Planning & Zoning Commission Hearing: November 16, 2023

Polestar Village PDP220010

Summary of Request

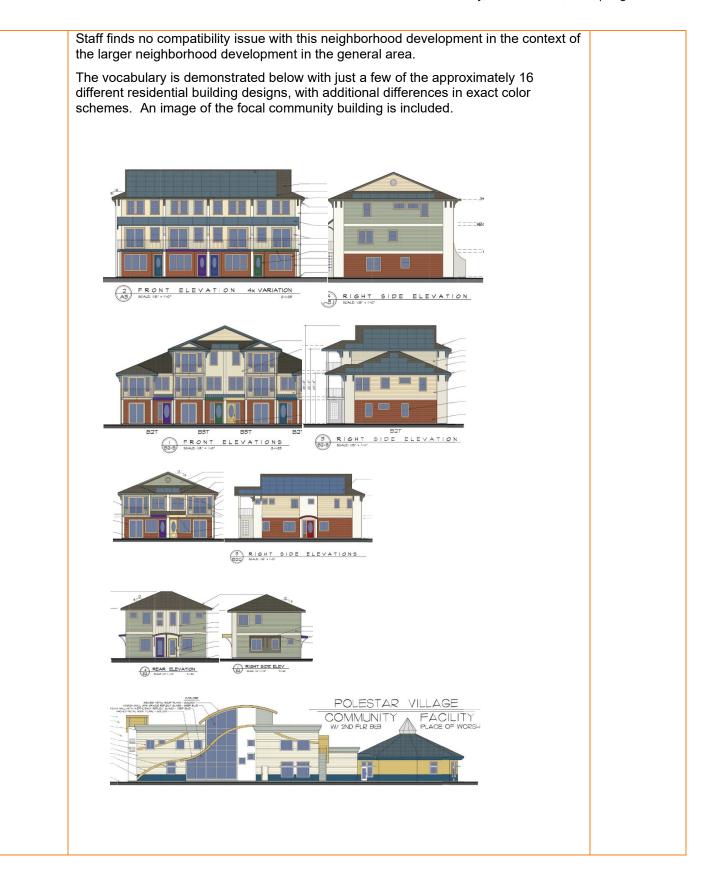
D. DIVISION 3.5 - BUILDING STANDARDS

Applicable Code Standard	Summary of Code Requirement and Analysis	Staff Findings
3.5.1(A) and (B) – Building Project and Compatibility, Purpose, and General Standard	The purpose of this Section is to ensure compatibility of new buildings and uses with the surrounding context. Absent any established character, the standard requires that new buildings set an enhanced standard of quality for future projects or redevelopment in the area. The standards in this section complement the more specific requirements in Section 3.8.30 for multi-family development, and in Article 4 for the LMN zone.	Complies
	Overall, staff finds that the design of the PDP is compatible with the existing context surrounding the site, which includes residential development from different eras in different styles.	
	 The plan's collection of multiple building types demonstrates a high degree of variation within a distinct unifying overall vocabulary.

• The design provides visual interest at a human scale consistent with the pedestrian orientation of the overall plan. The design vocabulary includes hip and gable roofs with 5/12 pitch; lap siding; porches and balconies; and details including shaped privacy walls with latticework, varied exposure of siding, and differently colored doors.	
	 Color shades are common residential colors, and they vary dramatically within the unifying overall order to distinguish different dwelling units within buildings and highlight design features. 	
	 Buildings are mostly two stories with some three story portions and a few 3- story apartment buildings which use secondary roofs to divide the mass into proportions that express the base, middle and top.
